**LEBANON PLANNING BOARD
DECEMBER 17, 2024 - 7:00 PM
COUNCIL CHAMBERS, CITY HALL OR
REMOTE VIA VIRTUAL PLATFORM
LEBANONNH.GOV/LIVE**

Re: The Brickyard Multi-family Planned Unit Residential Development (PURD)
174 Hanover Street Ext. & 238 Hanover Street (Map 48 Lots 1, 2, & 4 and Map 63 Lot 1)
Project Description and Impact Statement for Site Plan Review

Re: Proposed Multi-Family Development ("The Brickyard").
Site Plan Review Application
PUD/PURD Narrative Pieces

2 Bedford Farms Drive
Suite 200
Bedford, NH 03110
603.391.3900

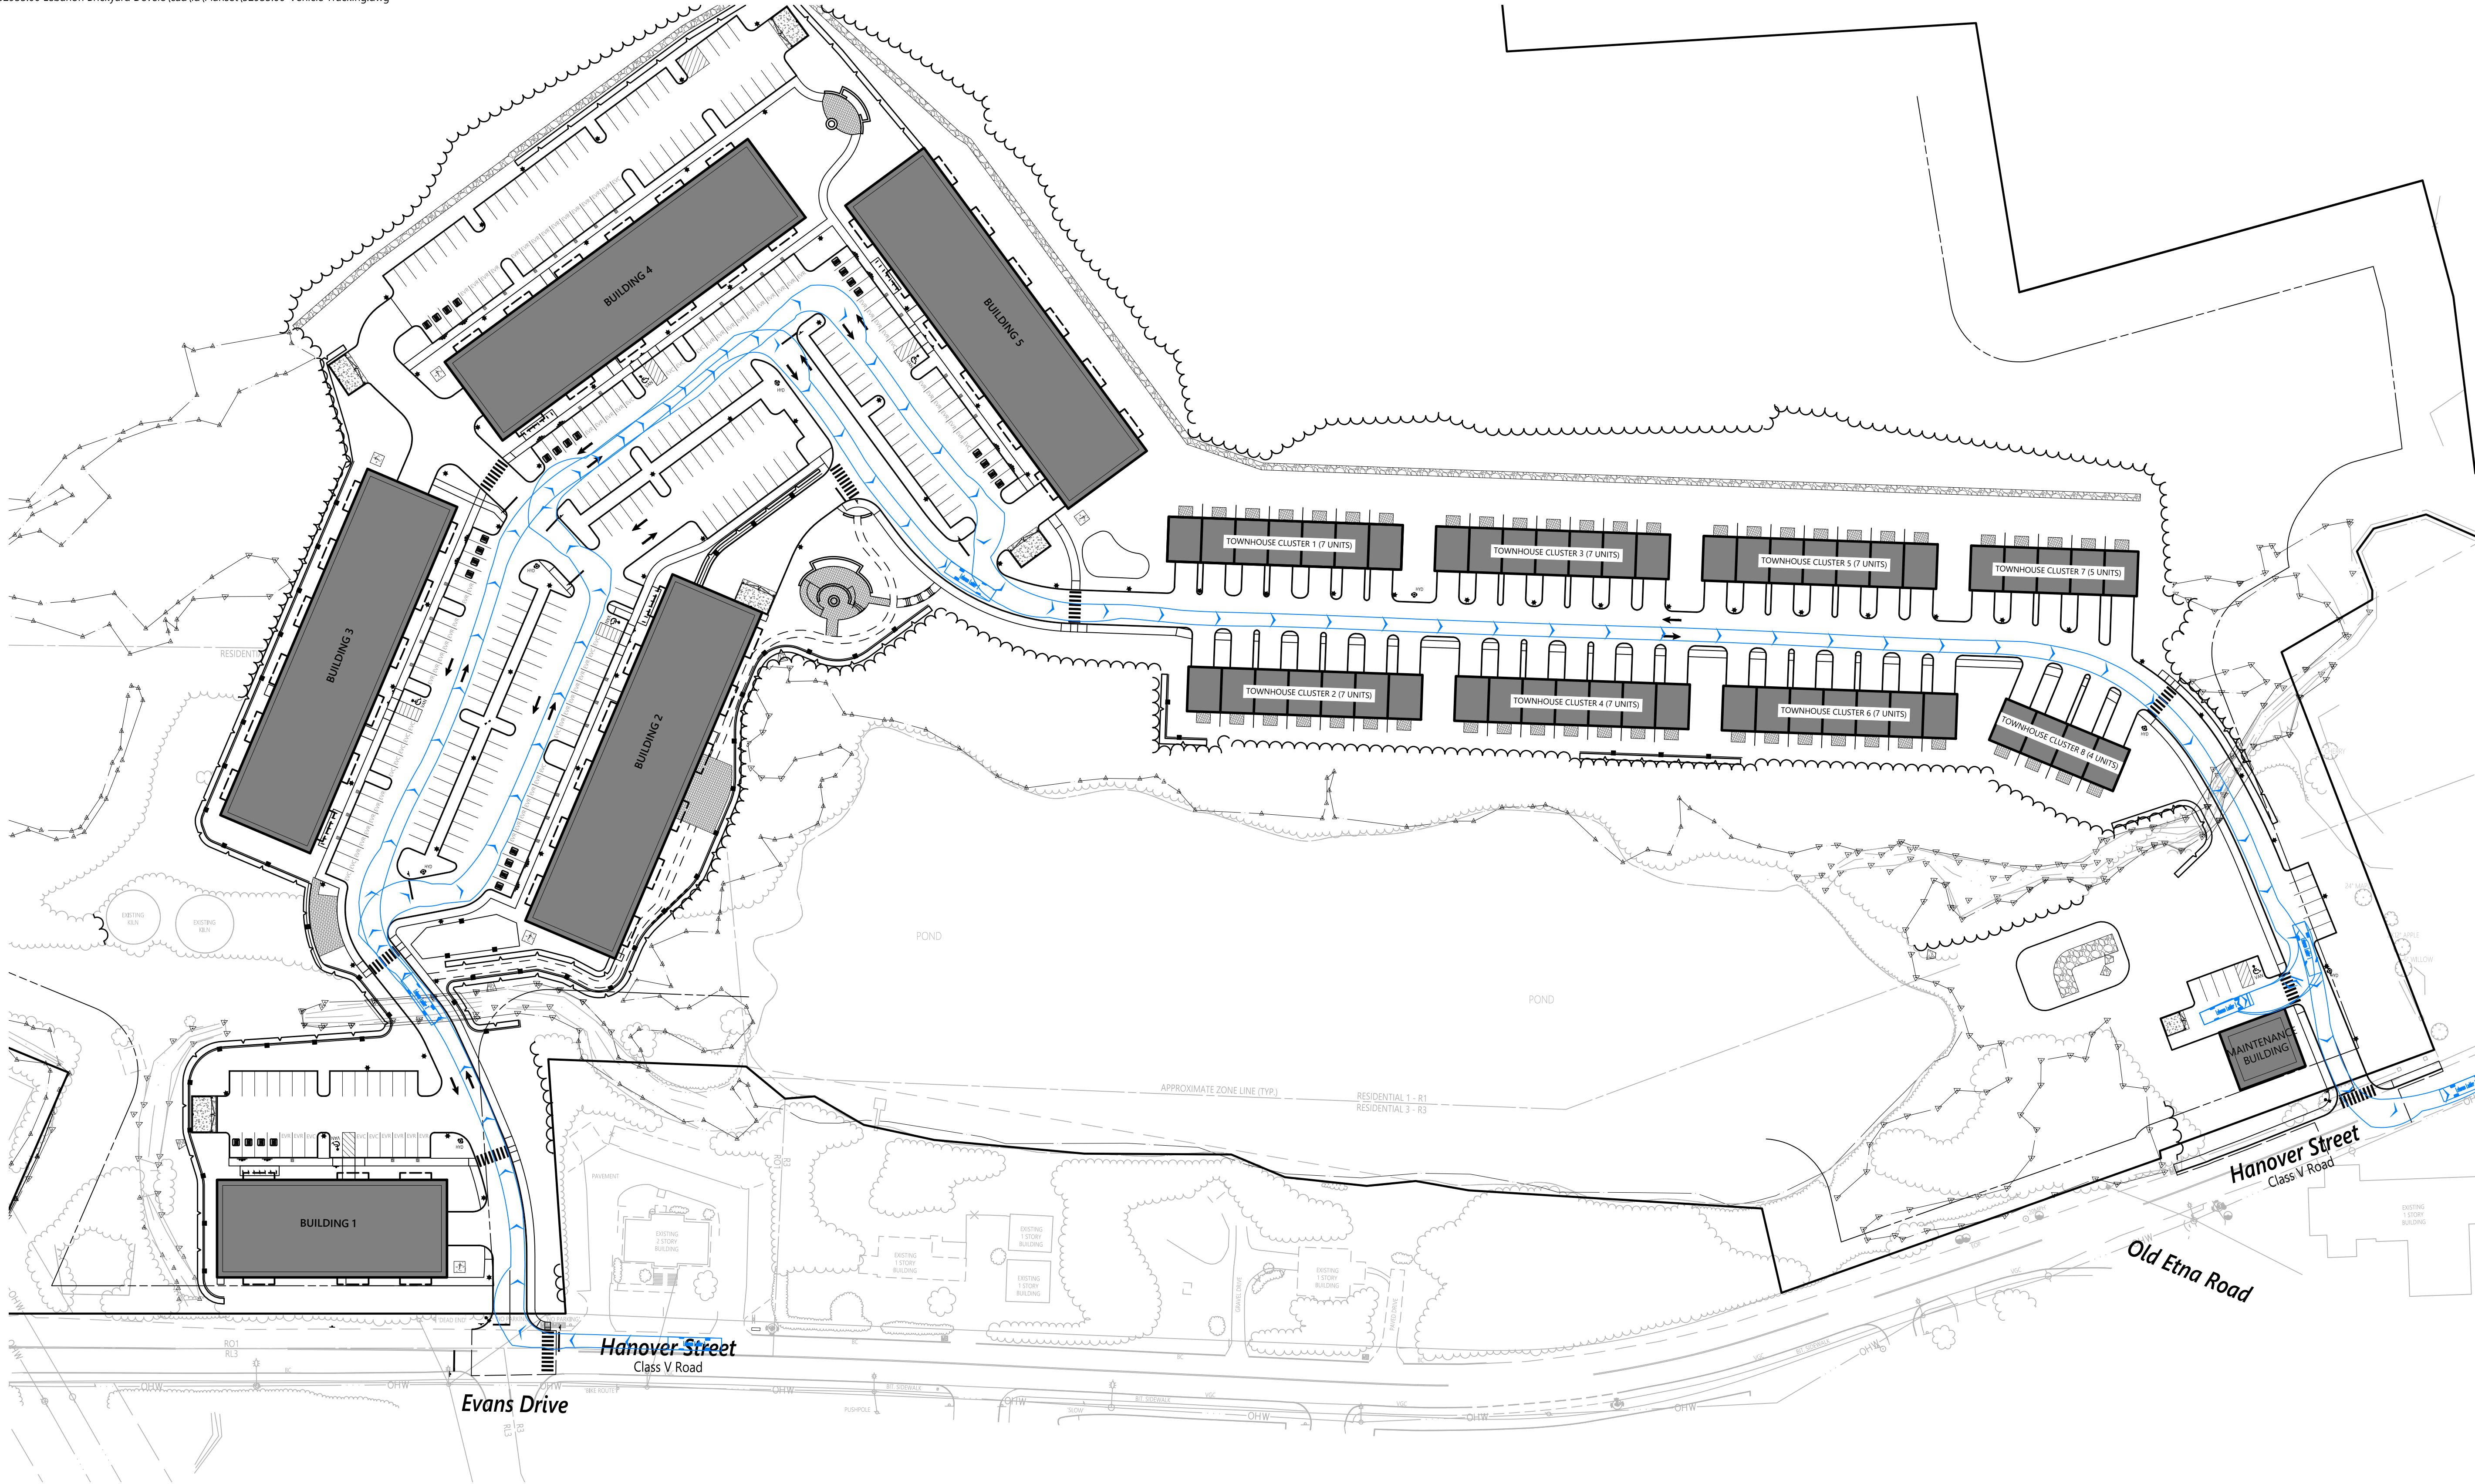
Comment 20. ***Phasing Plan - Sheets 30-33 (C8.1-4)***

Vehicle Tracking
WB-50

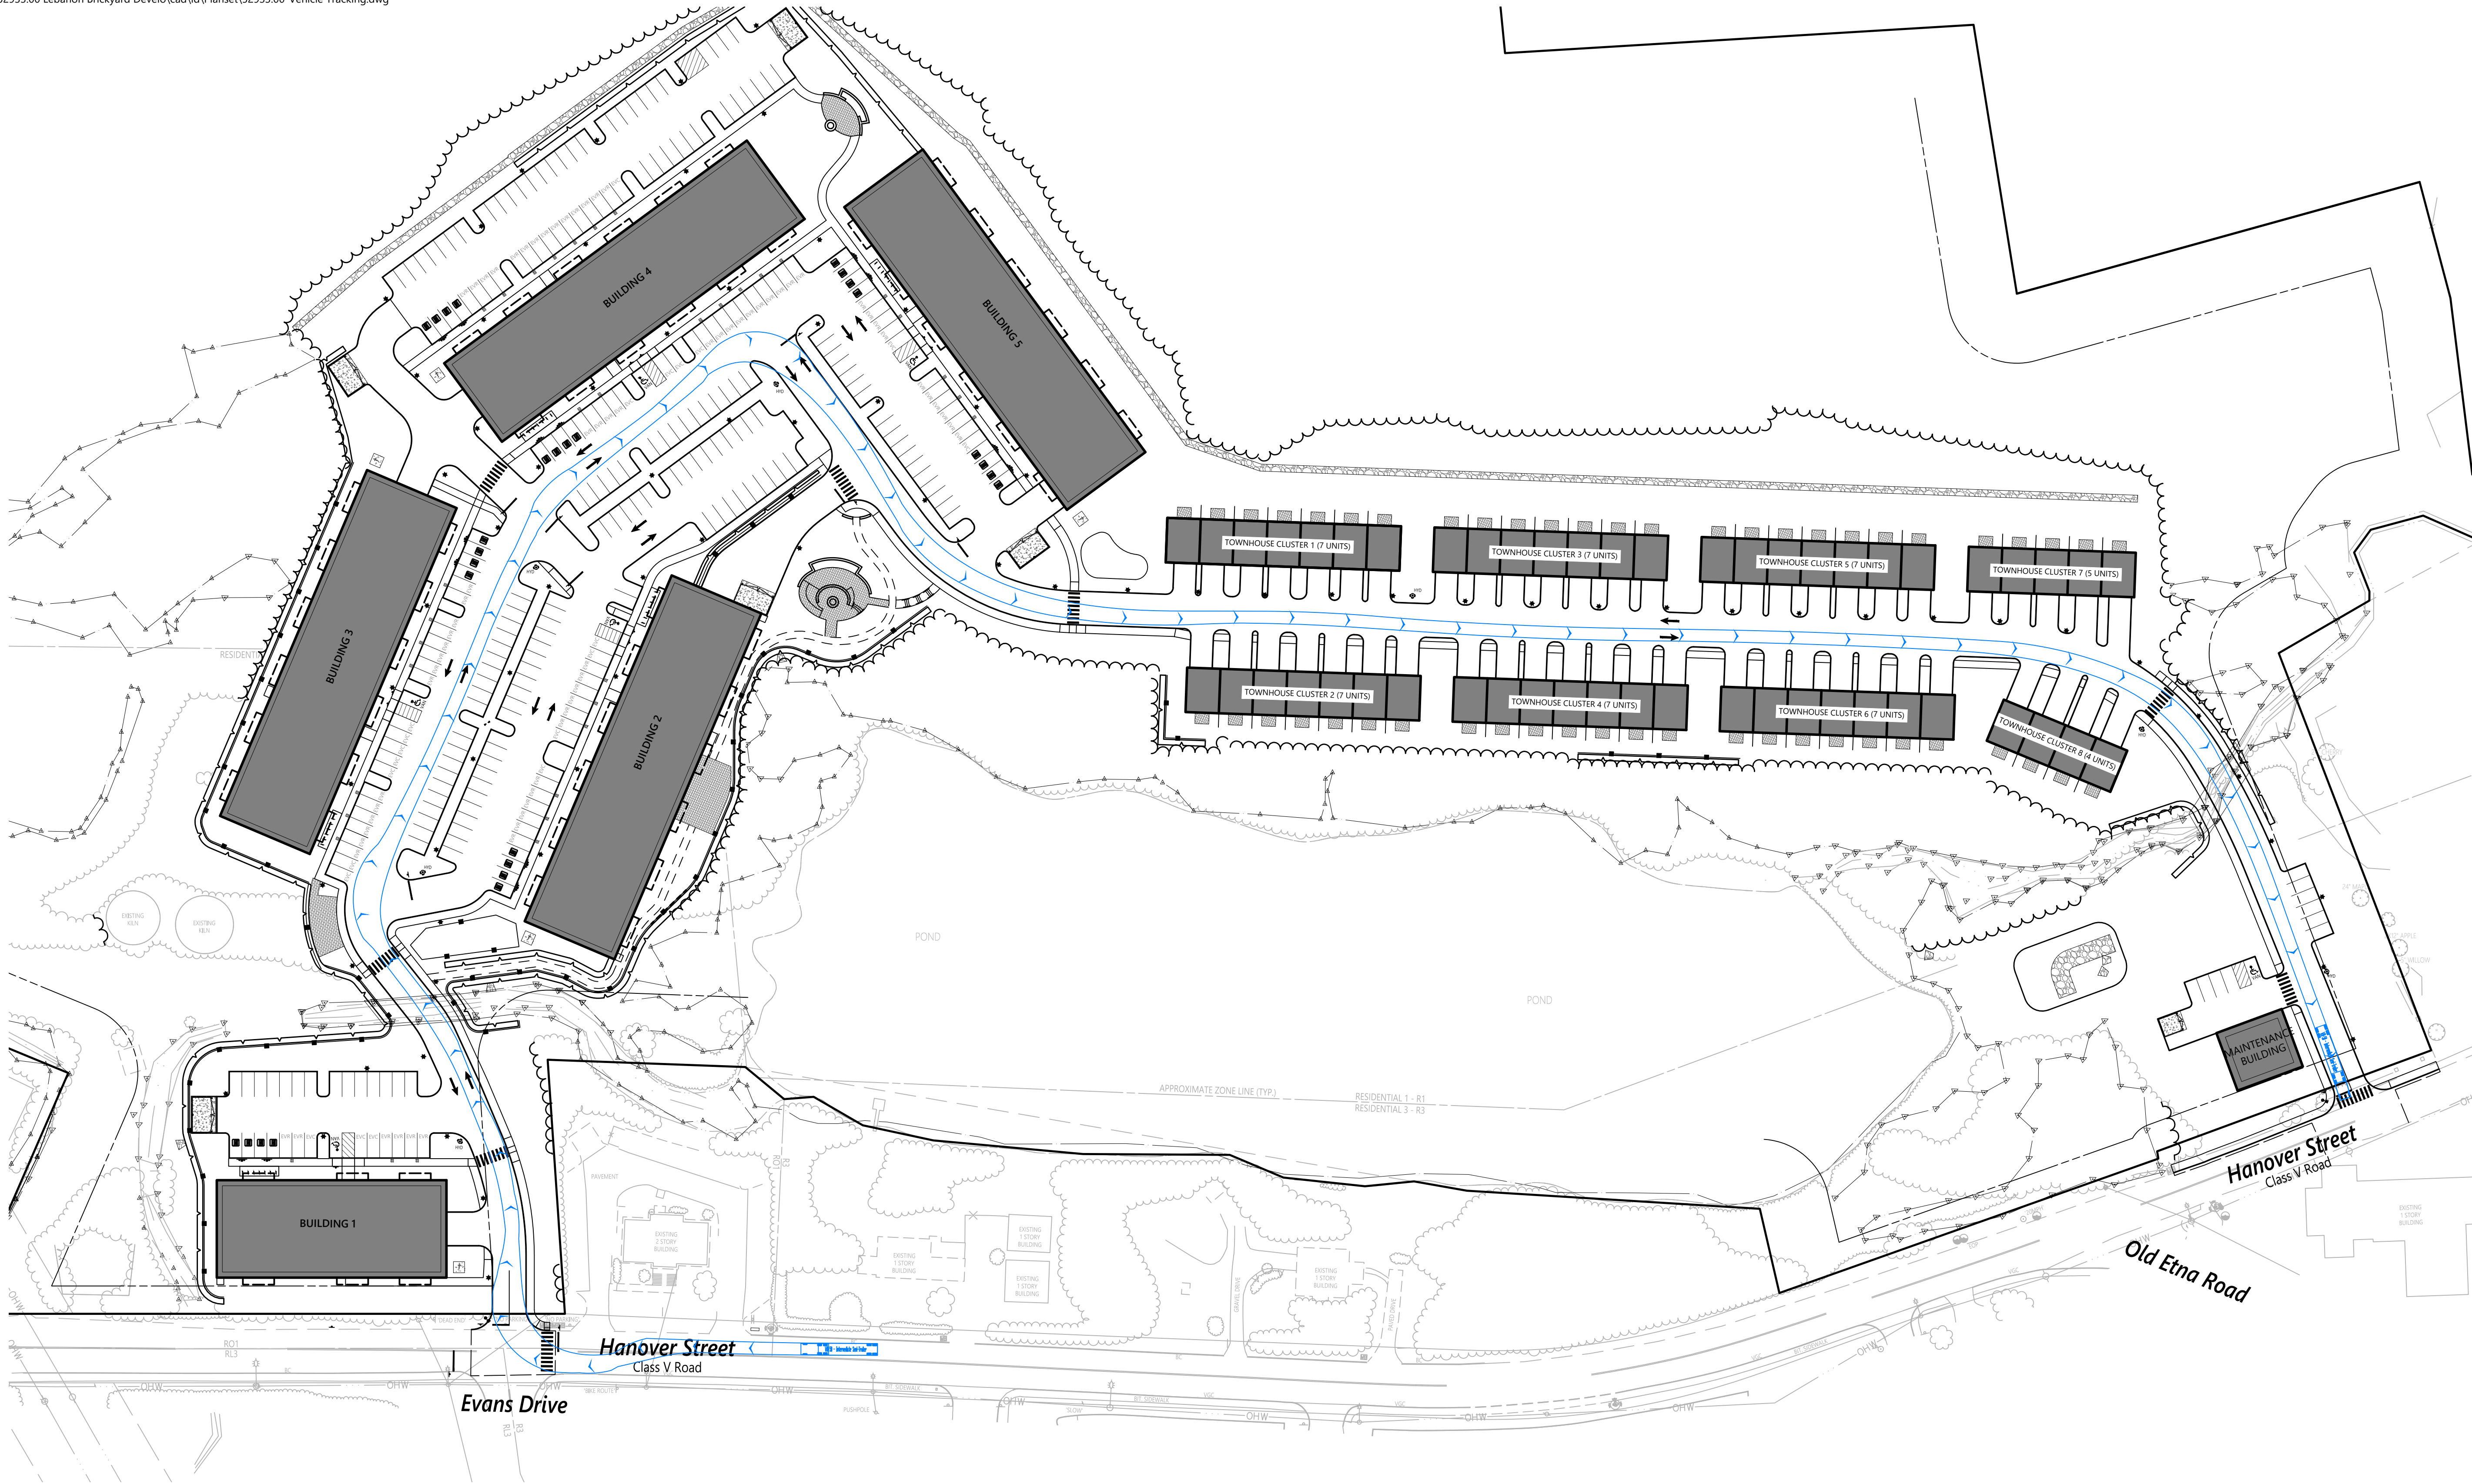
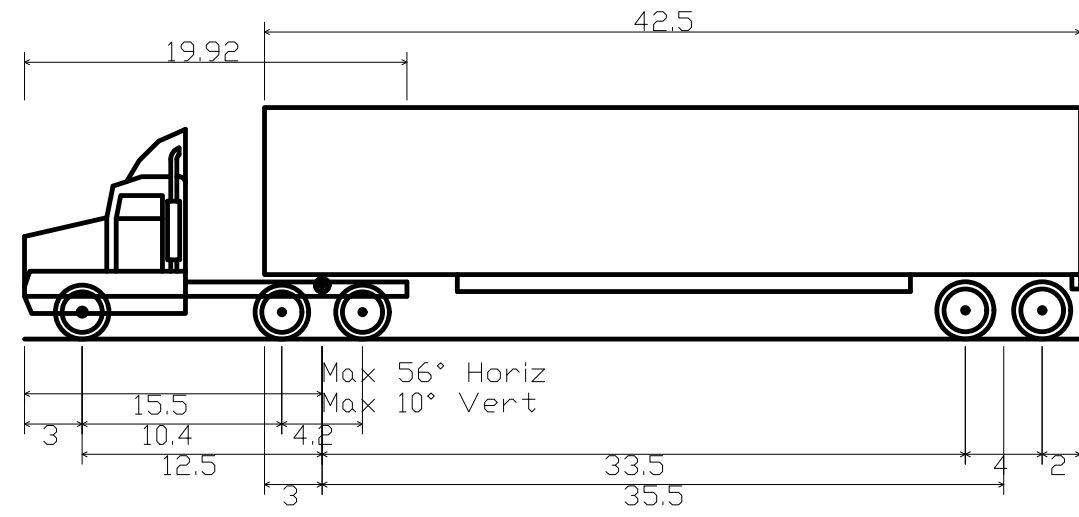
Comment 11. Sheet 36 – why does the development need to be designed to accommodate a semi-trailer?
